**ADDENDUM No. 4**

<b>Project</b>	T.A. Blakelock H.S. Renovations - Phase 1	<b>Project No.</b>	2215A
<b>Location</b>	1160 Rebecca Street, Oakville, Ontario	<b>Date of Issue</b>	2023 04 03
<b>Owner</b>	Halton District School Board	<b>File</b>	2215/7.1.3

**A4-2 DRAWING NO. 300 LEVEL 0 REFLECTED CEILING PLANS AND DETAILS (reissued)**

Drawing Title:  
**LEVEL 0 REFLECTED CEILING PLANS AND DETAILS**

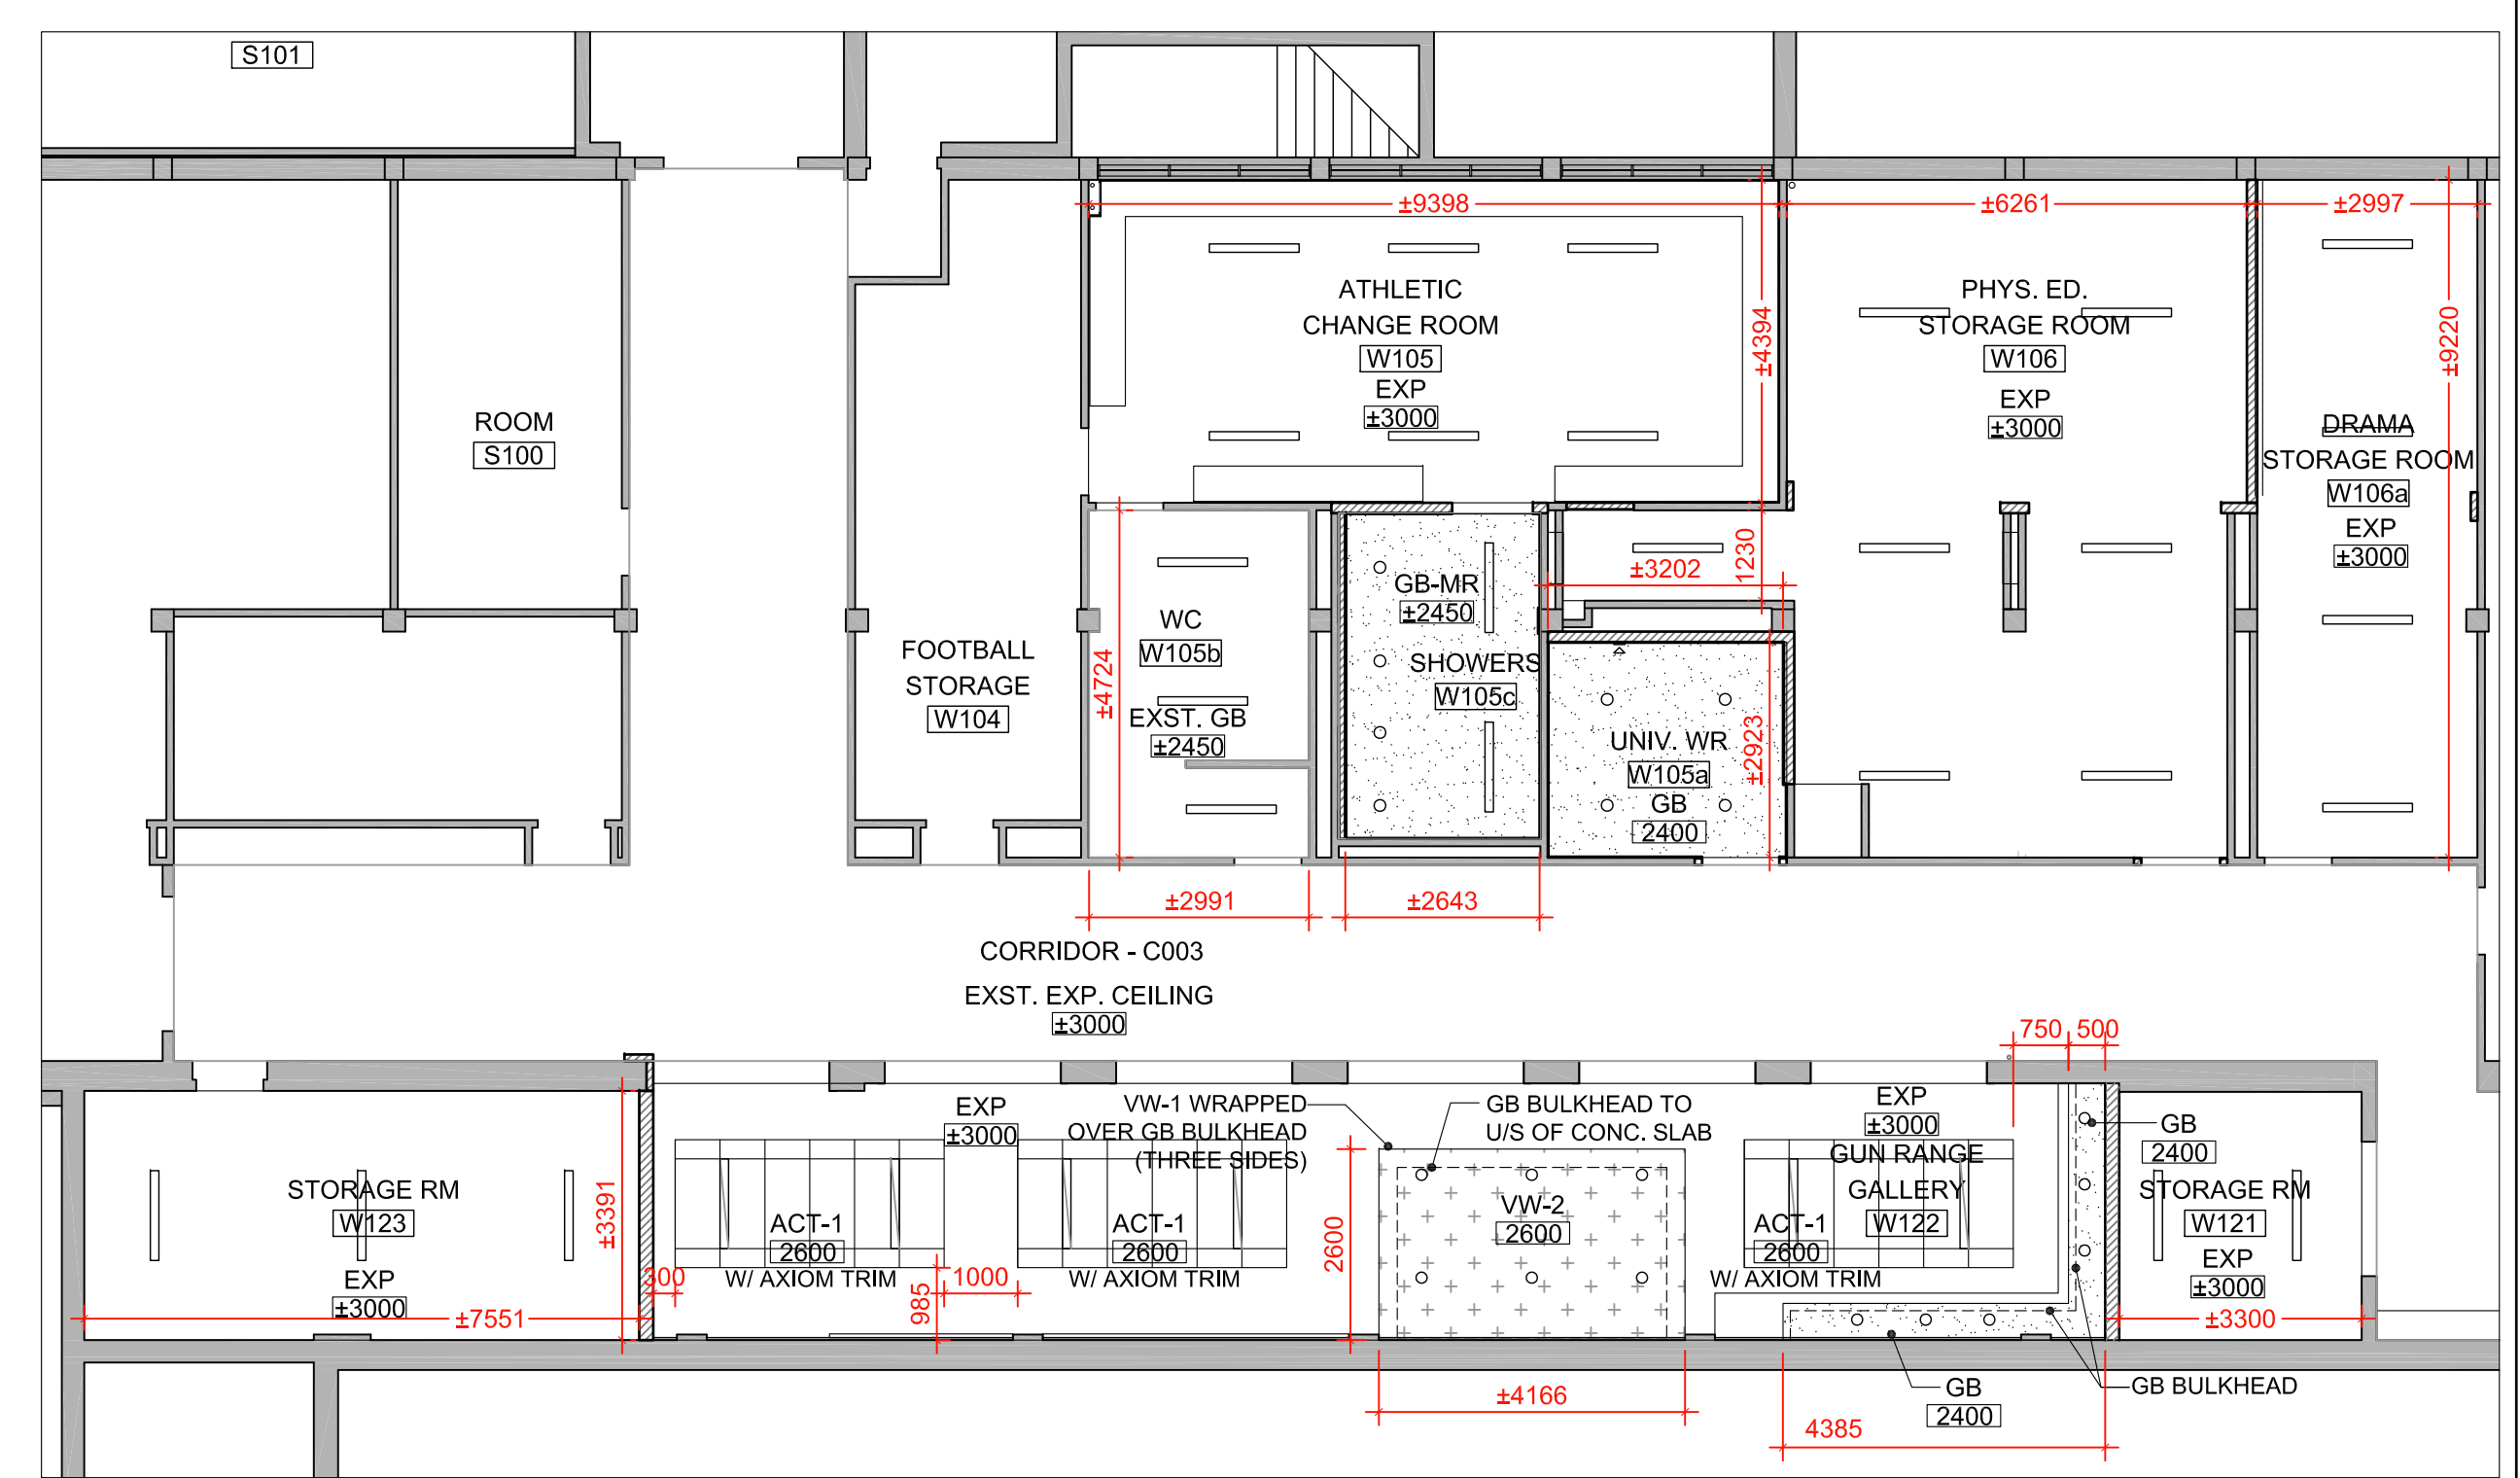
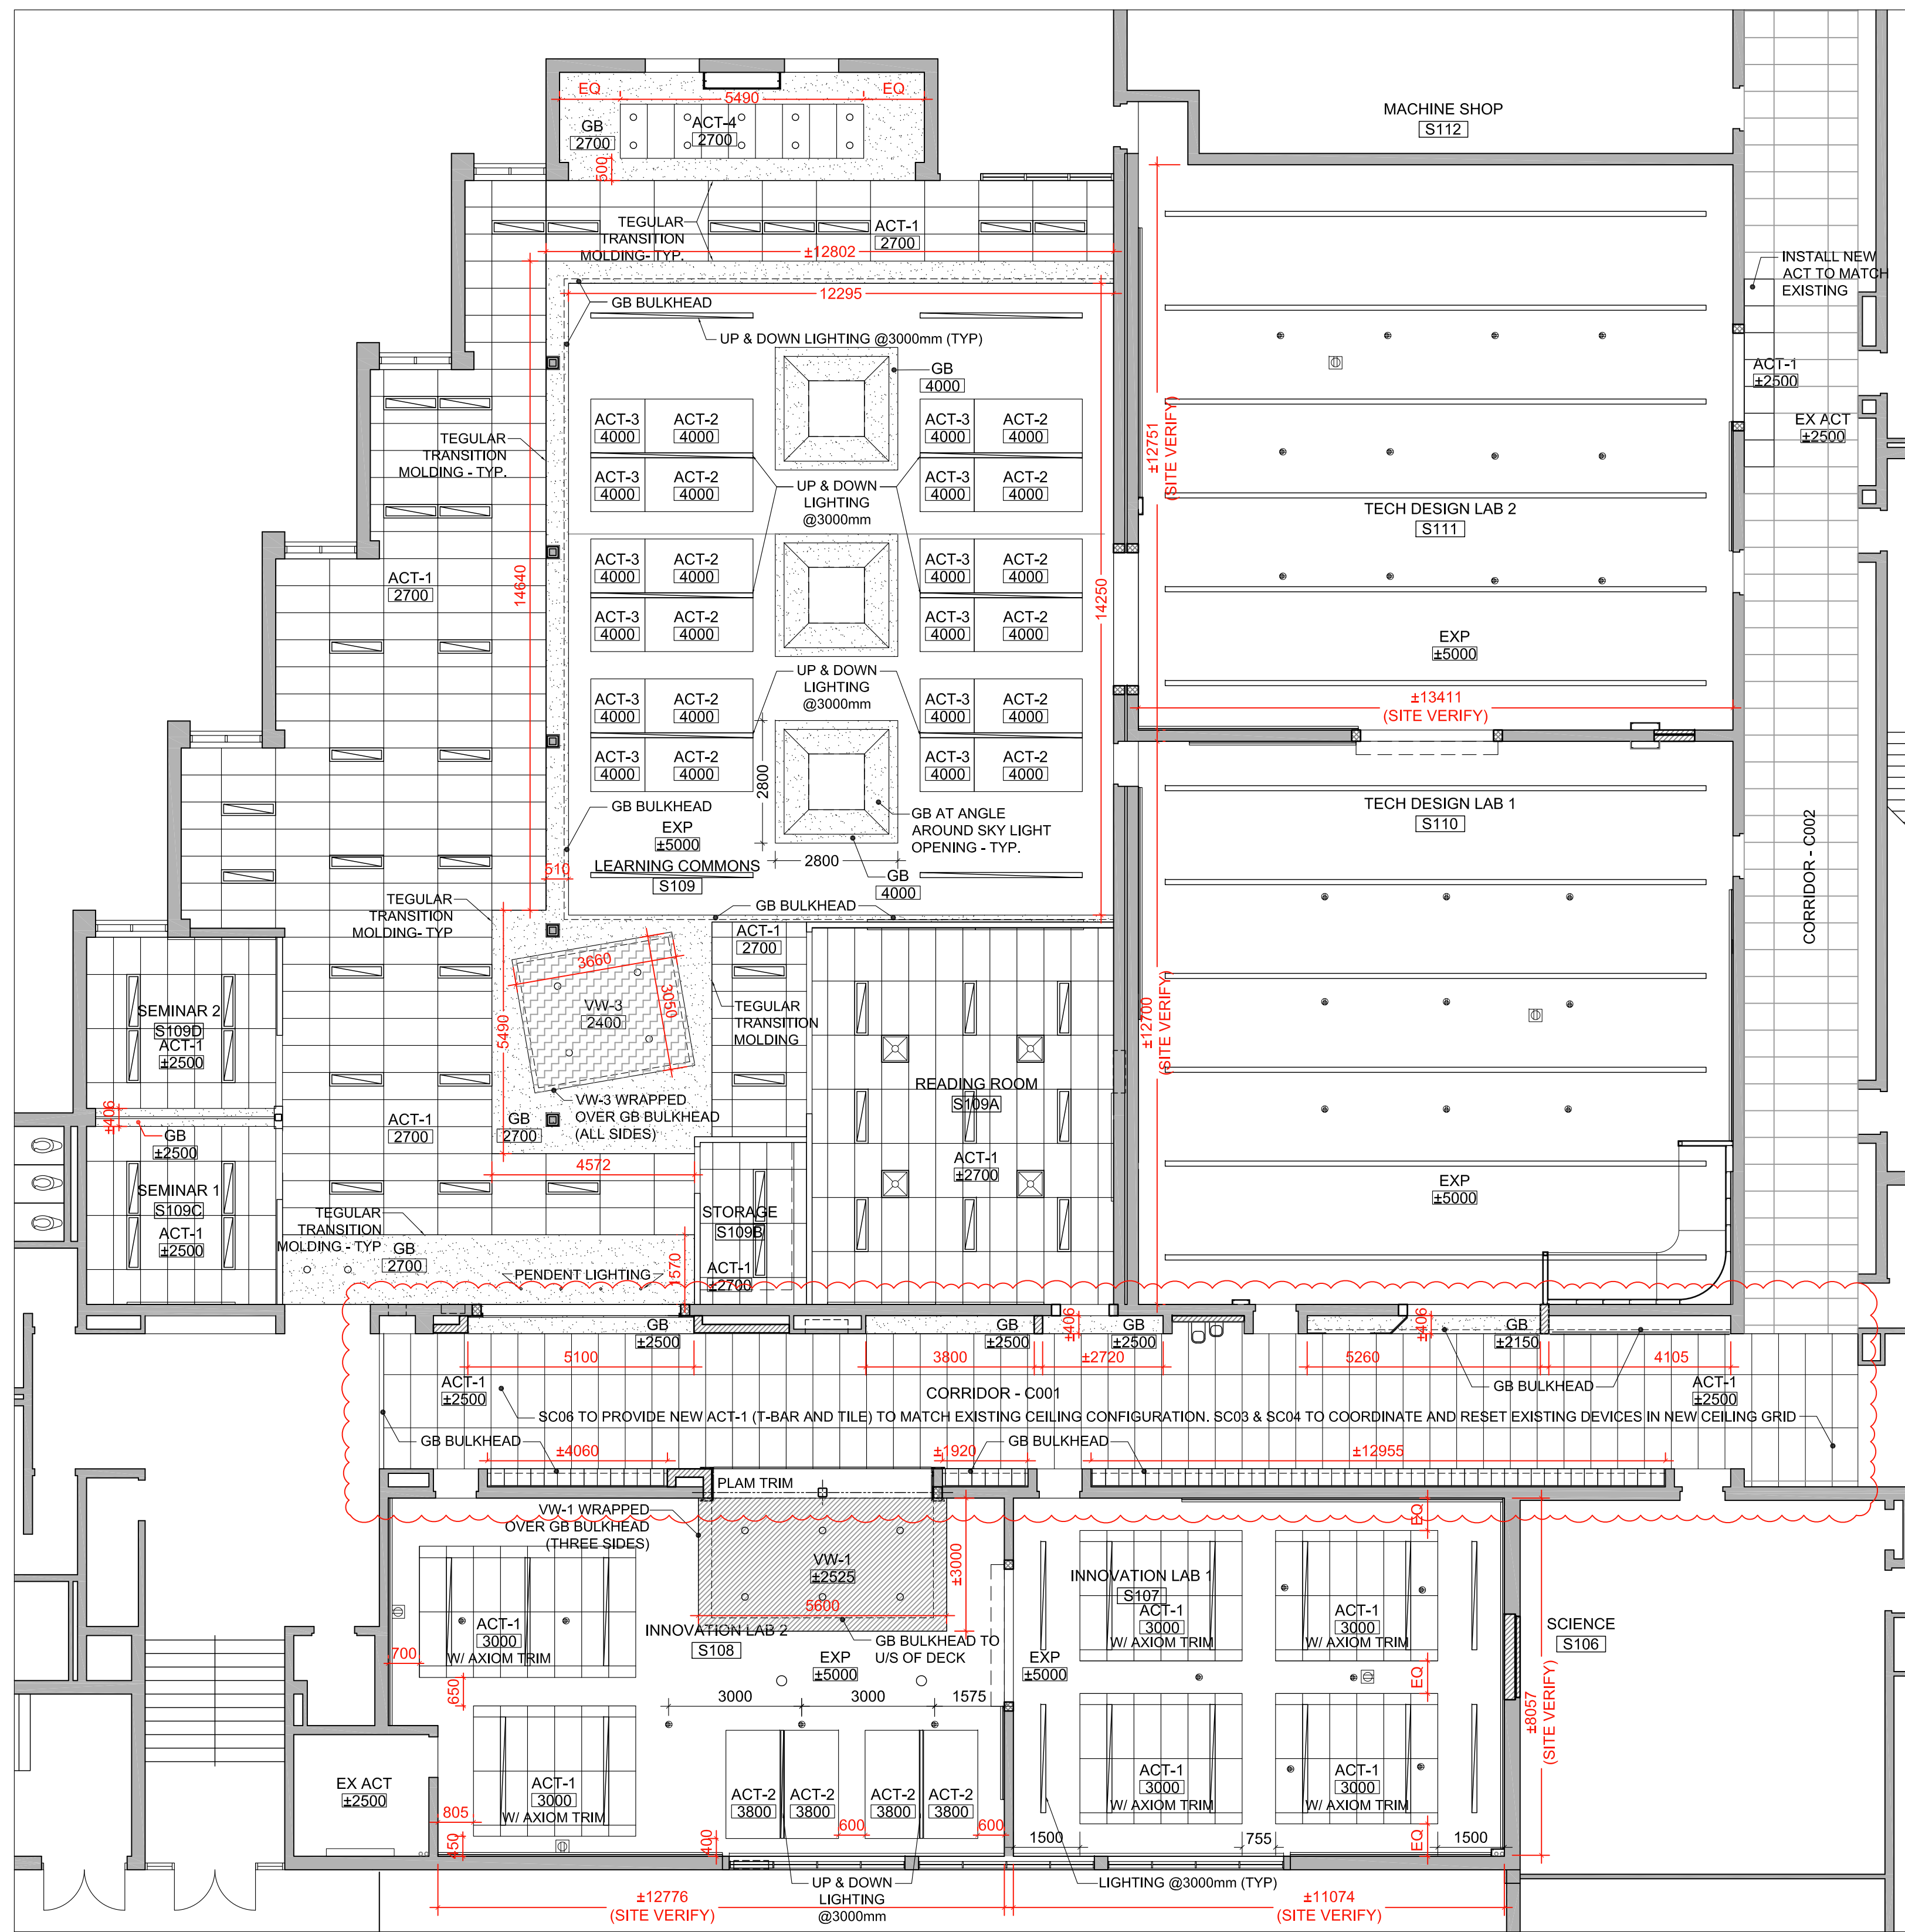
- .1 Replace drawing with the attached Revision No. 2.
- .2 Revisions include the following:
  - .1 Ceiling replacement in Corridor C001 ; SC06 DRYWALL & ACOUSTICS to provide new ACT-1 (T- bar and tiles) to match existing ceiling configuration. SC03 MECHANICAL & SC04 ELECTRICAL to coordinate and reset existing devices in the new ceiling grid.
  - .2 Additional ceiling dimensions in red.
